# UNITED STATES PATENT AND TRADEMARK OFFICE

APPLICATION NO.	FILING DATE	FIRST NAMED INVENTOR	ATTORNEY DOCKET NO.	CONFIRMATION NO.
10/829,275	04/22/2004	Kazuaki Suzuki	1551-0155PUS1	6464
2292 7590 06/10/2009 BIRCH STEWART KOLASCH & BIRCH PO BOX 747 FALLS CHURCH, VA 22040-0747				
EXAMINER WINDELL, MARK R				
ART UNIT 3635		PAPER NUMBER		
NOTIFICATION DATE 06/10/2009		DELIVERY MODE ELECTRONIC

# Office Action Summary

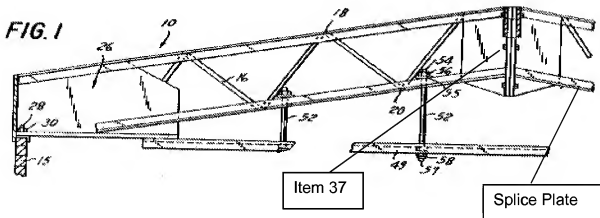
Claims 1-4, 7, 12-16, 19 and 24 are rejected under 35 U.S.C. 102(b) as being anticipated by Wippermann (US 3474578). Regarding claims 1 and 13, Wippermann illustrates in Figures 1-4 a joint structure and a structural member (15), comprising:

- o A gusset plate (34 or 39), said gusset plate being formed from a flat plate having first and second opposed faces; and

- A plurality of splice plates (14) connected to said gusset plate, each of said plurality of splice plates being constructed from section steel (see column 2, line 25 where the applicant states that the invention includes an all-steel roof) having a cross-section perpendicular to a longitudinal axis thereof that is L-shaped, at least one of said plurality of splice plates having a face in direct contact with the first opposed face of said gusset plate and at least another of said plurality of splice plates having a face in direct contact with the second opposed face of said gusset plate.

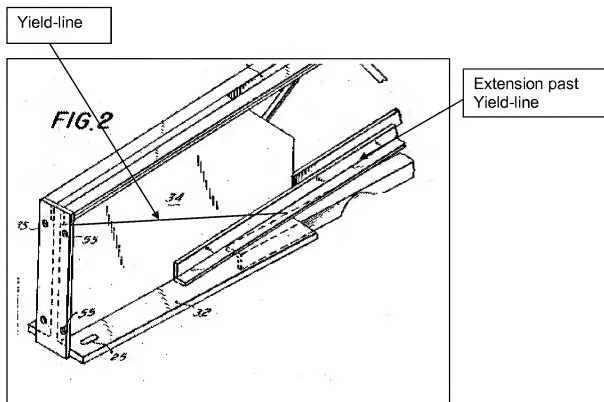
Regarding claim 27, Wippermann illustrates in Figures 1-4 the splice plates being connected to structural members 16, 26, 42 and 52.

Regarding claim 28, Wippermann illustrates in Figure 1 the step of connecting the gusset to a structural member of a building (15) via item 28.

Regarding claim 29, Wippermann illustrates in Figure 2 the gusset (34) attached to the building (15), the preexisting gusset including a stiffening rib (35) attached thereto, said method further comprising the step of connecting said first end of at least one of said plurality of splice plates (14) to the stiffening rib of the preexisting gusset. The examiner notes that the term "connecting" can include an intermediate structure or structures between the items being connected.
